COMMISSION ACTION

NCPC File No. Z.C. 09-21

TEXT AND MAP AMENDMENTS TO THE ZONING REGULATIONS OF THE DISTRICT OF COLUMBIA, UNION STATION NORTH (USN) ZONING DISTRICT

TAFF RECOMMENDATION

Impacts to Union Station

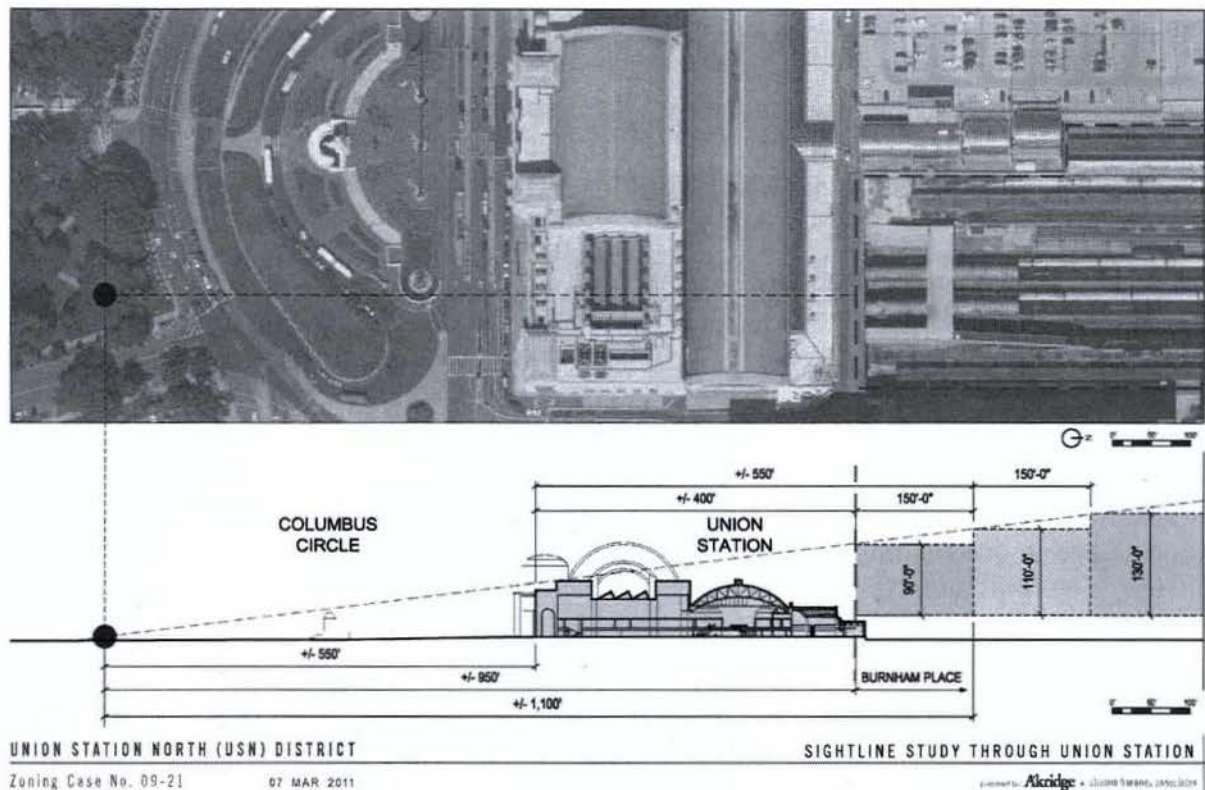
A federal interest in this proposed Zoning Commission action is the impact on the character of Union Station, Columbus Plaza and the contributing viewsheds of Louisiana and Delaware Avenues. Designed by Daniel Burnham, Union Station was completed in 1908, was placed on the National Register of Historic Places in 1969, and is the central hub for rail transportation in Washington DC. It is described in the McMillan plan as “the grand gateway to the capital” the style of which “should be equally as dignified as that of the public buildings themselves”. In 1979, the National Register was amended to include the plaza in front of the station as well as Columbus Fountain. The Station and plaza are proximate to the United States Capitol Building, supporting Senate Office buildings as well as The Smithsonian Postal Museum. The physical and visual connection between Union Station and the US Capitol is a key aspect of the McMillan Plan and are part of the defining character of this part of the city. It is also specifically referred to as a place of interest in Height of Buildings Act of 1910. The Burnham Place project and the Union Station North Zoning District are directly adjacent to Union Station and its design has the potential to affect the character of this area. At its January 6, 2011 meeting, NCPC reviewed amendments to the District Elements of the Comprehensive Plan for the National Capital. One particular amendment pertained to the importance of Union Station and maintaining its character during development of the Burnham Place project. NCPC staff worked directly with DCOP staff to develop policy language that reflects the sensitivity of this area. The language, as reviewed by NCPC and adopted by The Council of the District of Columbia states:

In the original DCOP proposal for the Union Station North zoning, the regulations would have permitted buildings measuring 130 feet, as measured from the elevated H Street, NE overpass to directly abut Union Station. This would have resulted in buildings being approximately 34 feet above the Union Station vault and approximately 85 feet above the Station's east wing. These height regulations were subsequently modified by the Zoning Commission.

The proposed USN zoning further provides that if the Zoning Commission determines that the structures in these two areas are of “exceptional architectural quality,” an additional 20 feet of height may be granted. This additional height would then result in buildings directly adjacent to Union Station being approximately 13 feet above the Union Station vault and 64 feet above the east wing.

Staff is supportive of the step down approach as employed in the current USN zoning proposal. This represents a sound solution relating this development to its surroundings and preserving the character of historic buildings and adjacent neighborhoods. However, staff has concerns with the bonus height provision included in the USN zoning as it is unclear what standard will be used to determine “exceptional architectural quality” and therefore that the bonus height could negatively affect the character of Union Station and the historically significant viewsheds to it. Further, this would be contrary to the aforementioned policy language in the District Elements of the Comprehensive Plan which specifically callout preservation of Union Station and the viewsheds to it. This goal is further reflected in the Federal Elements of the Comprehensive Plan, Preservation and Historic Features Element which state “views and vistas, both natural and designed, that are an integral part of the national capital’s image should be protected and enhanced”. The Element also states that “the reciprocal views along the rights-of-way of the Historic Plan of Washington DC as well as to and from squares, circles and reservations should be protected”. Regarding historic properties like Union Station, the Comprehensive Plan
